寄件者: 陳灝然
寄件日期: 2025年08月03日星期日 22:59
收件者: tpbpd/PLAND
副本: Peter Pak Lun NGAN/PLAND
主旨: A/NE-LYT/841 補充資料
附件: 31064-R01-02.pdf
類別: Internet Email

Traffic Impact Assessment for Section 16 Planning Application A/NE-LYT/841 for Proposed Temporary Open Storage of Construction Materials and Machineries with Ancillary Facilities for a Period of 3 Years and Associated Filling of Land at Various Lots in D.D. 83, Lung Yeuk Tau, New Territories

TRAFFIC IMPACT ASSESSMENT REPORT

Reference: 31064-R01-02

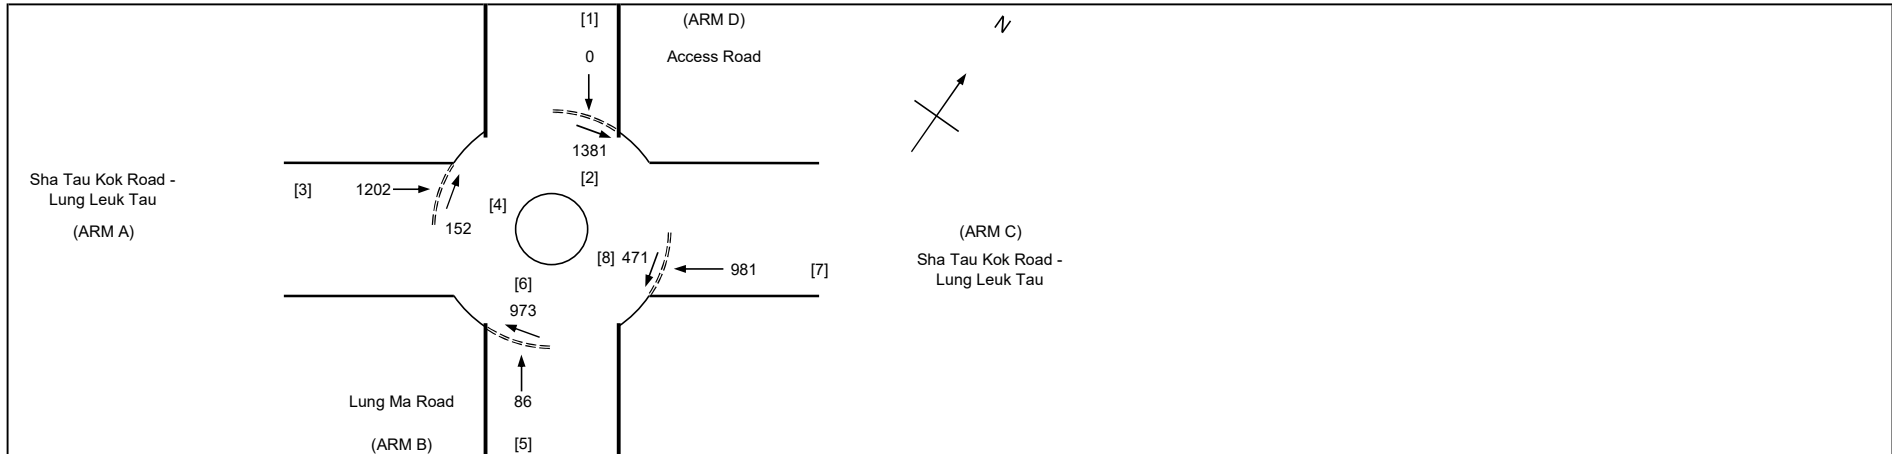
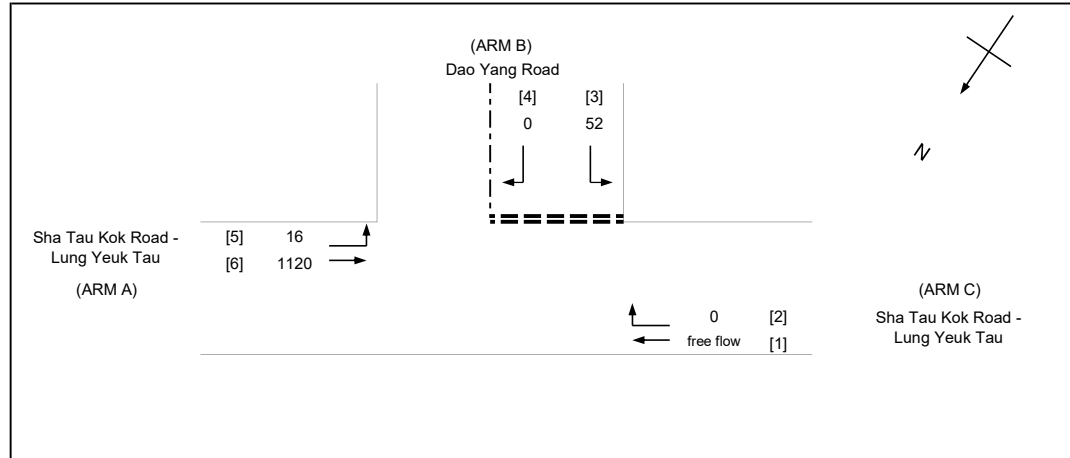
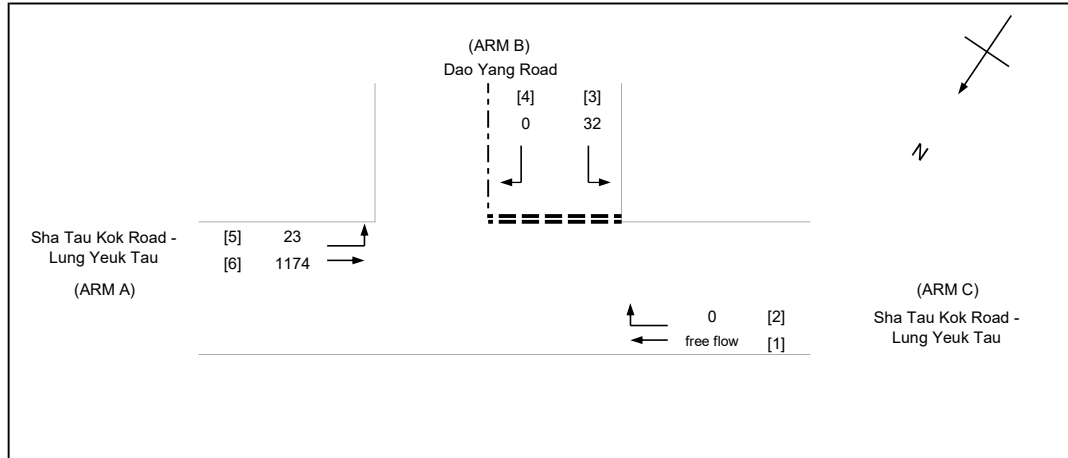
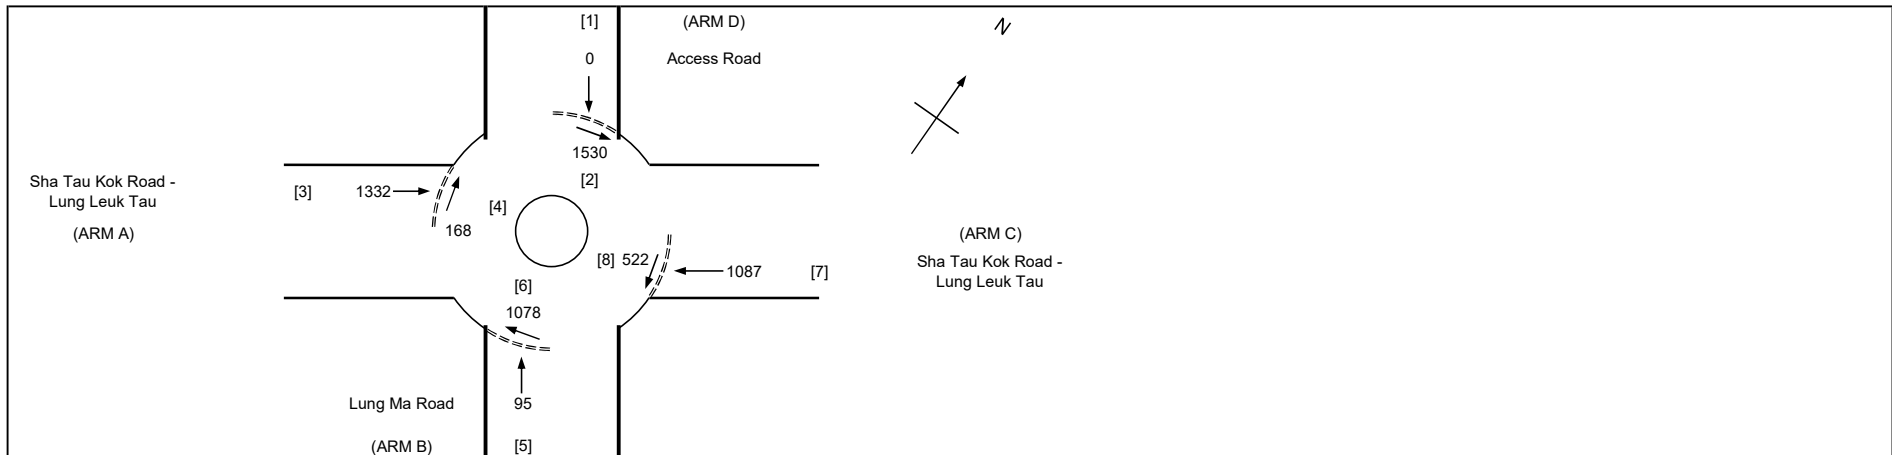
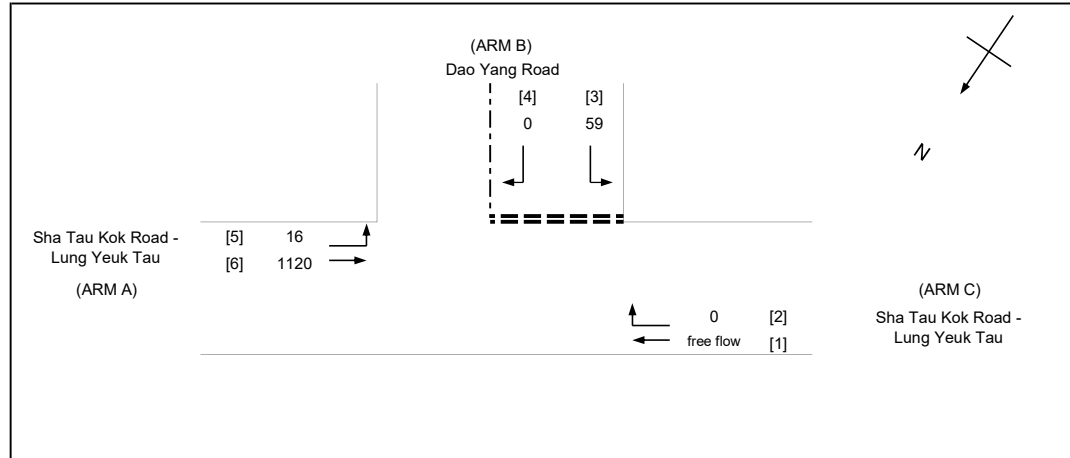
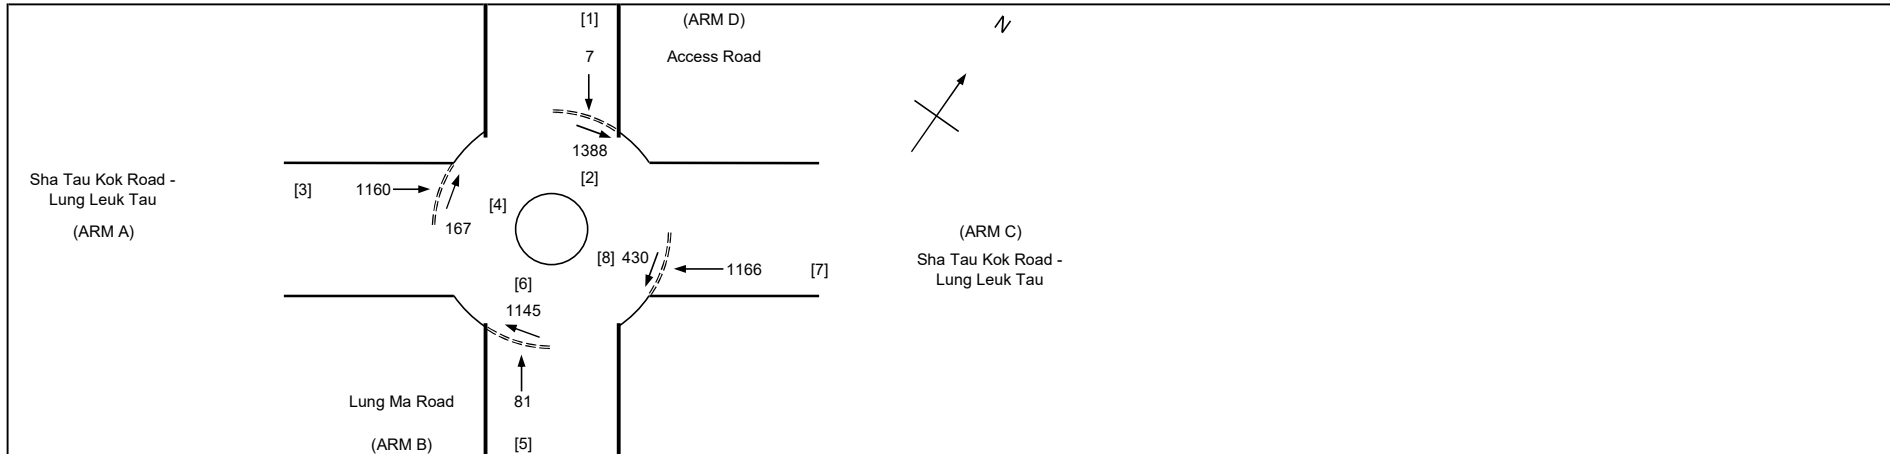
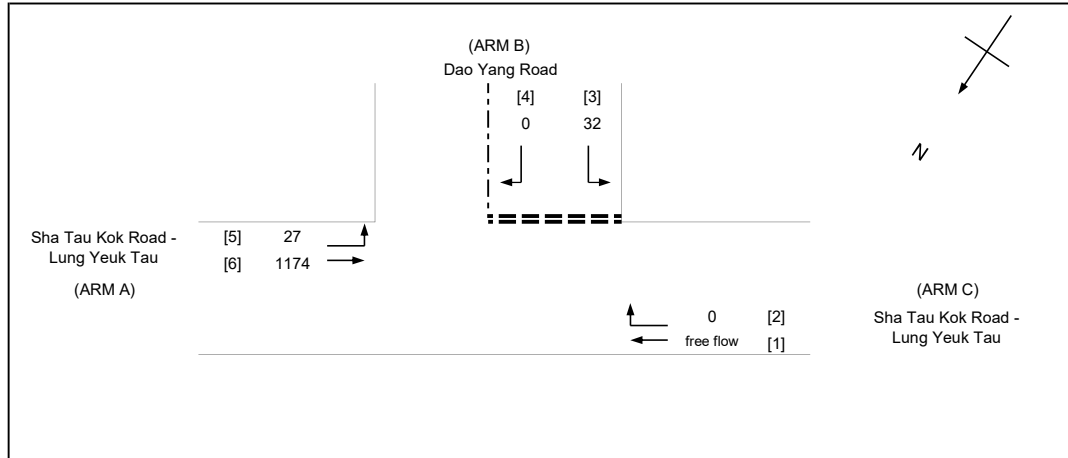
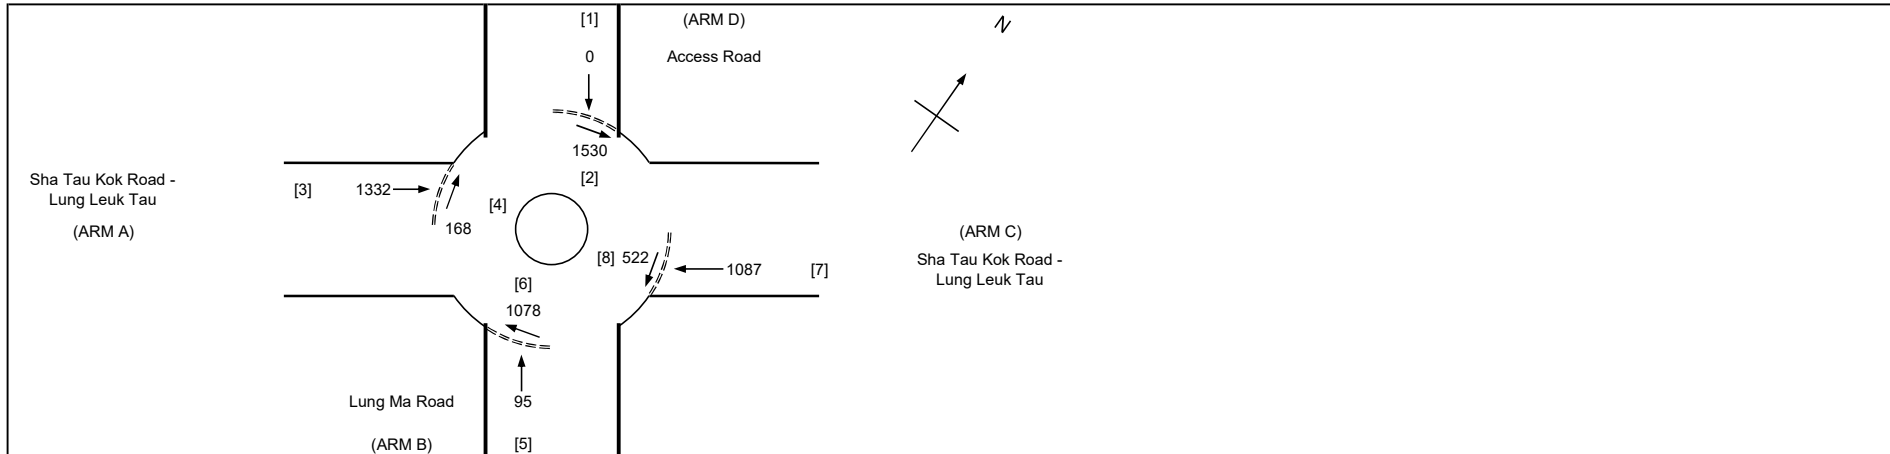
No	Transport Department's Comments	Responses
11	<p>(31.7.2025)</p> <p>Appendix A Priority Junction Calculations for 2025 Observed Traffic Flow – Peak, 2025 Observed Traffic Flow - PM Peak, 2028 Reference Traffic Flow – AM Peak, 2028 Reference Traffic Flow - PM Peak, 2028 Design Traffic Flow – AM Peak and 2028 Design Traffic Flow - PM Peak: Please advise why the central reserve width was stated to be 0.</p>	<p>(1.8.2025)</p> <p>The central reserve width has been revised to reflect the actual junction geometry, and all associated calculations have been updated accordingly in the revised submission.</p>
12	<p>(31.7.2025)</p> <p>The applicant shall advise the provision and management of pedestrian facilities to ensure pedestrian safety.</p>	<p>(1.8.2025)</p> <p>Pedestrian access will be supported by adequate signage and clearly marked footpaths within the Site, where appropriate, to be defined during the detailed design and site setup stage. As visitor frequency is expected to be low, pedestrian movement will be guided and controlled during operational hours to ensure safety and avoid conflicts with vehicular activities.</p>
